Subject: CERTIFICATE OF COMPLIANCE NO. 9292 FOR THE MODEL NO. PATRIOT
PACKAGE: Submission of Revision 3 to the Safety Analysis Report (SAR)

Enclosure 1: Patriot SAR Revision 3 Change Pages

Application for Certificate of Compliance for the Patriot BWR Fuel Shipping Package

NRC Certificate of Compliance
USA/9292/AF-85
Docket 71-9292

OPTIONAL PATRIOT BWR INNER SHIPPING PACKAGE AND SAFETY ITEMS

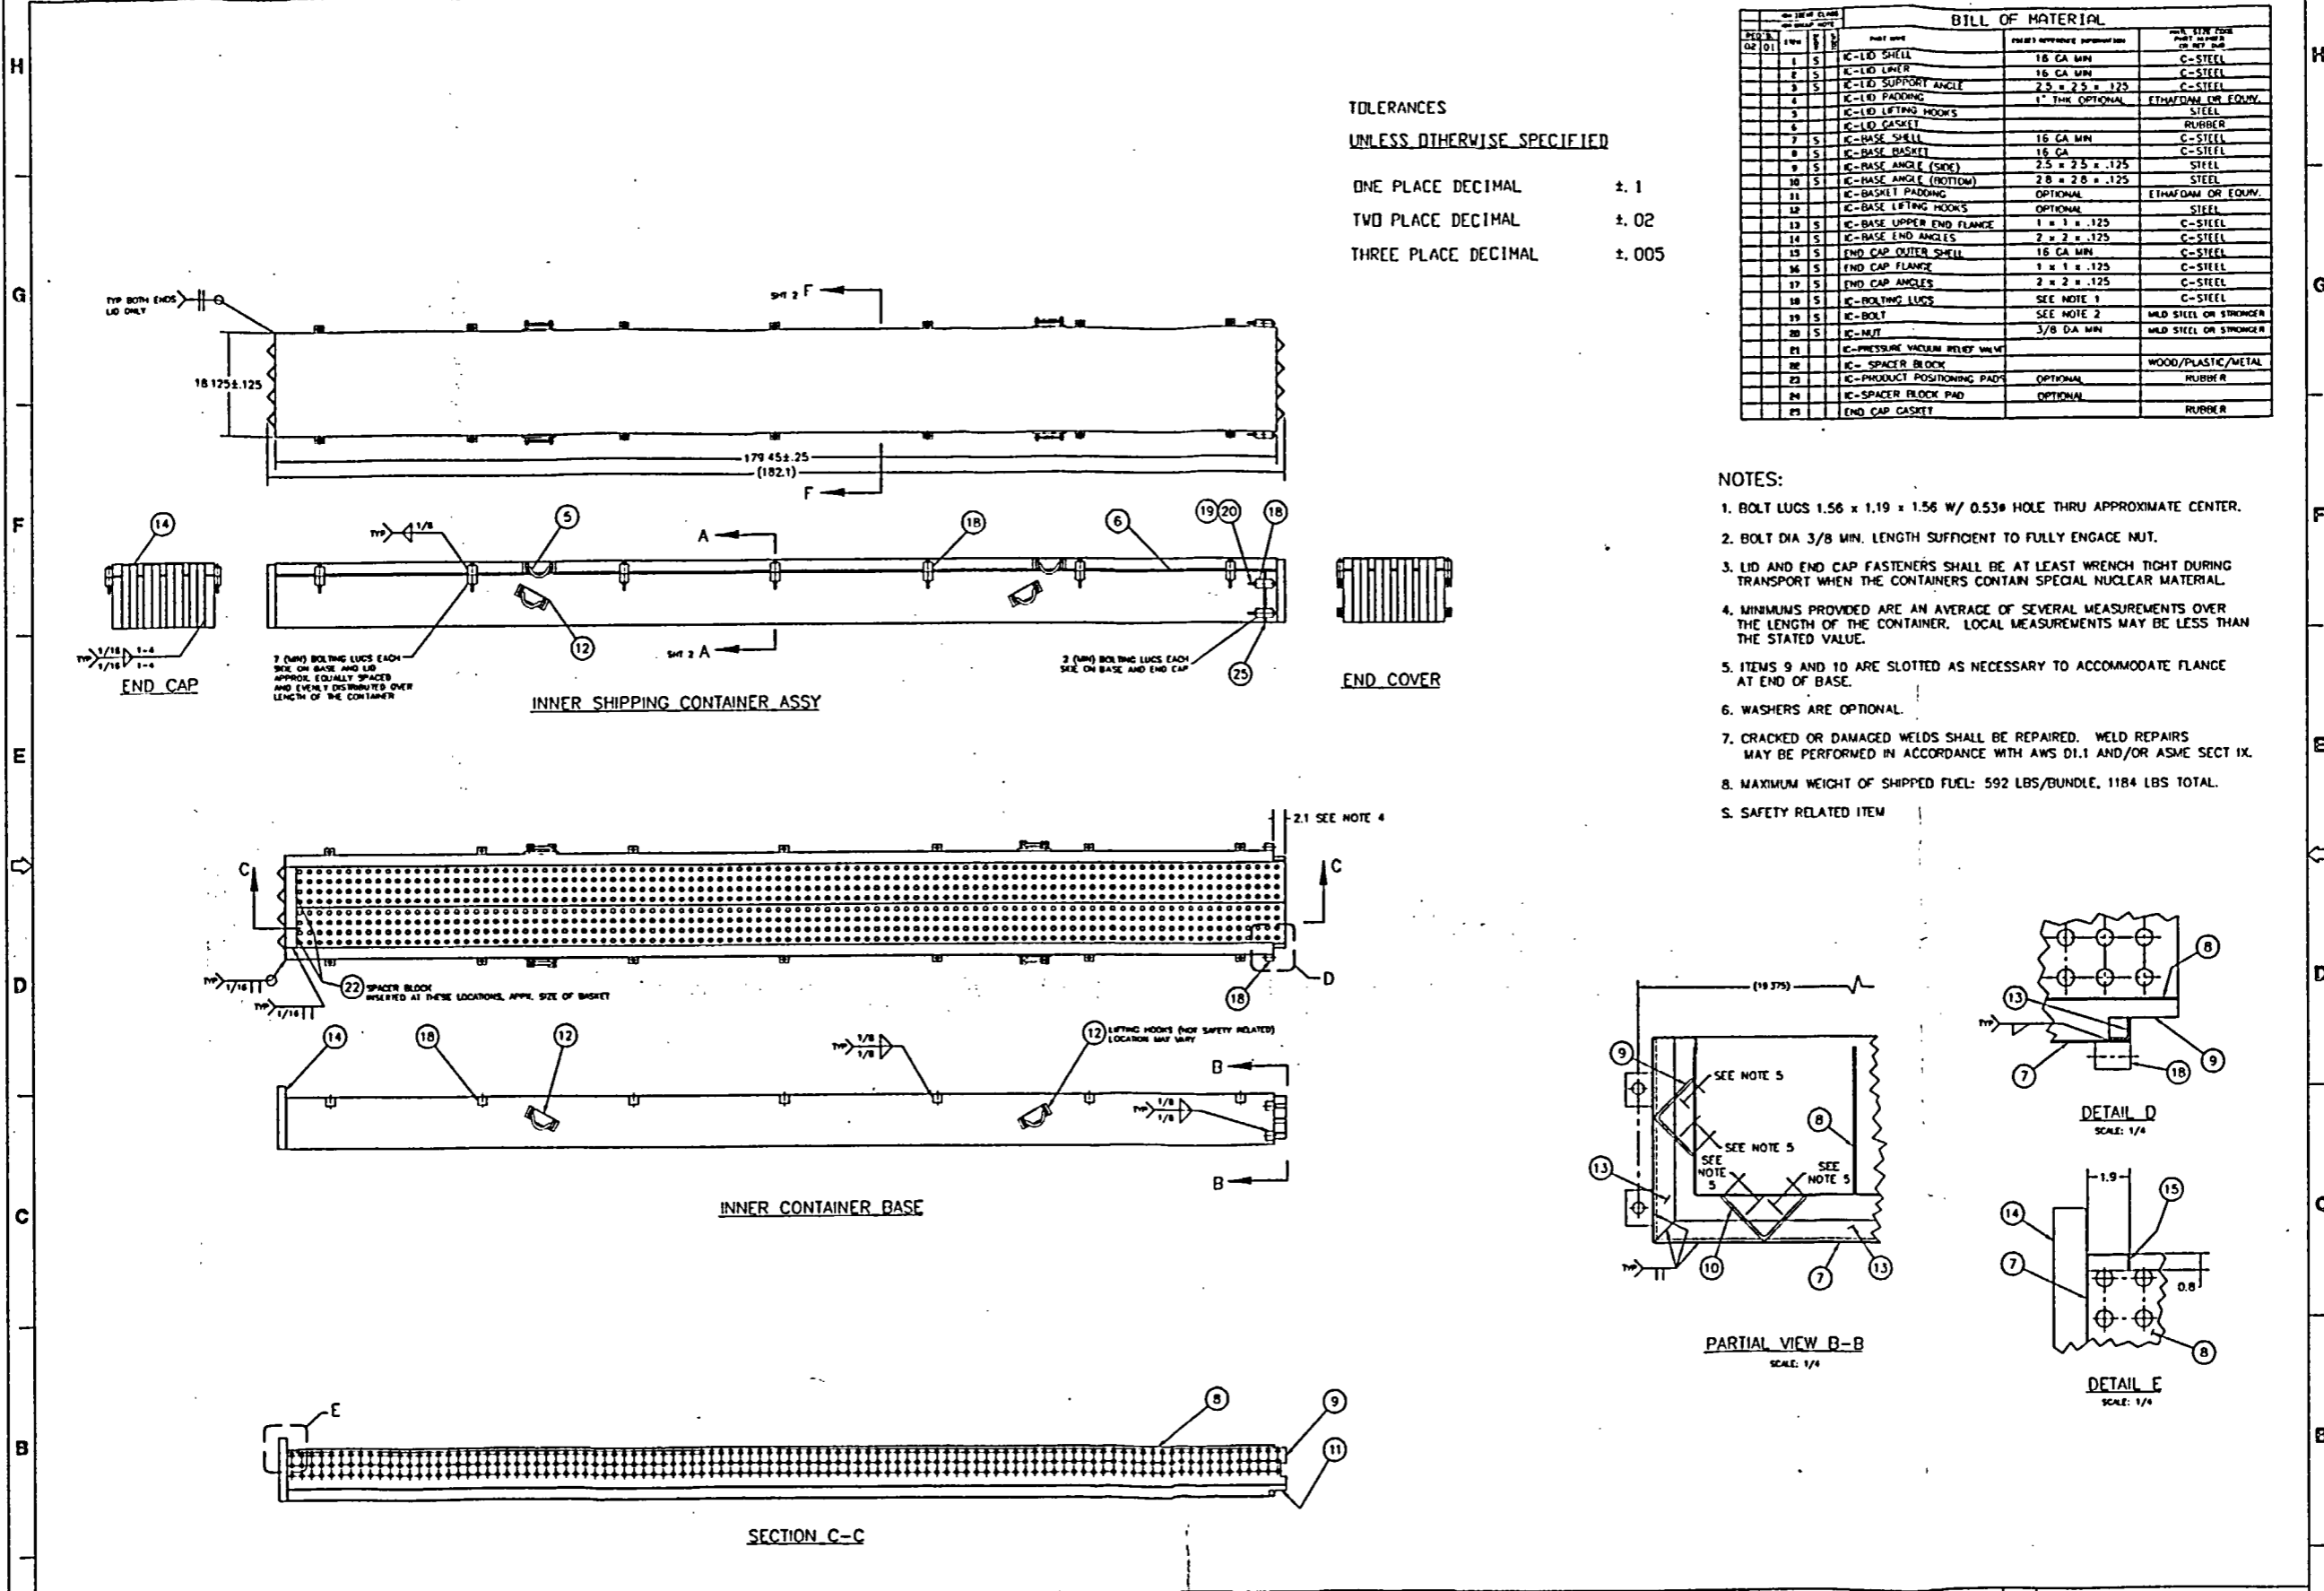
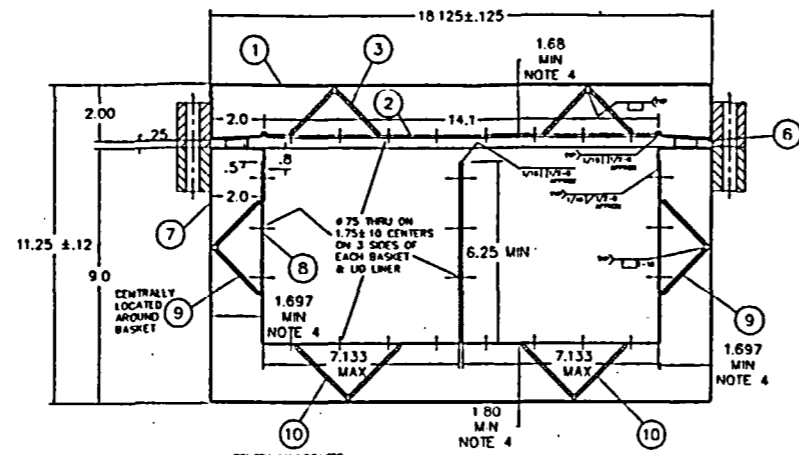
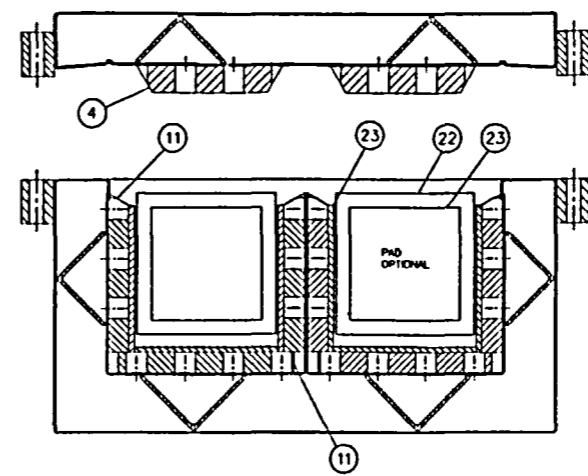
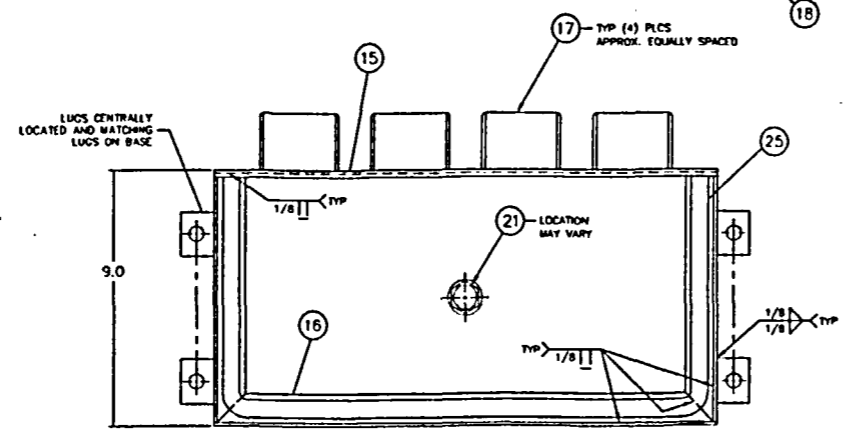
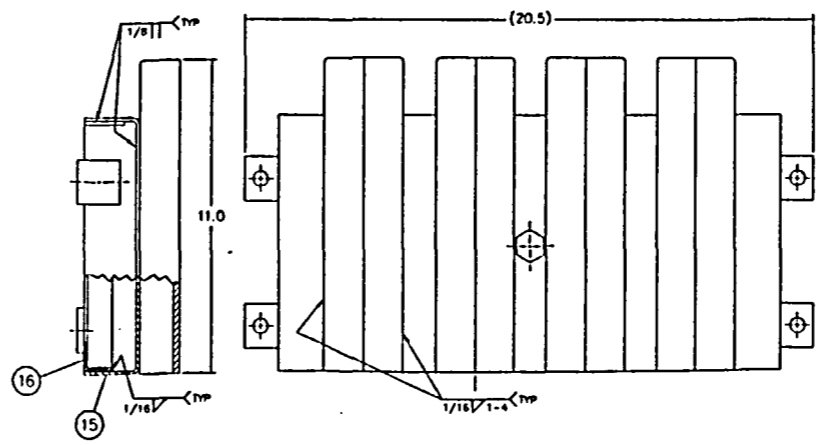
Page 1A-1: Revised sentence describing the license drawings to include drawing #10015E58, Optional Patriot Inner Container. This drawing is identical to License drawing #L-9272-01 from the CE-B1 SAR.

Added new License Drawing 10015E58, Optional Patriot Inner Container.

Add the following line:

10015E58, Sheets 1 and 2, Rev. 1
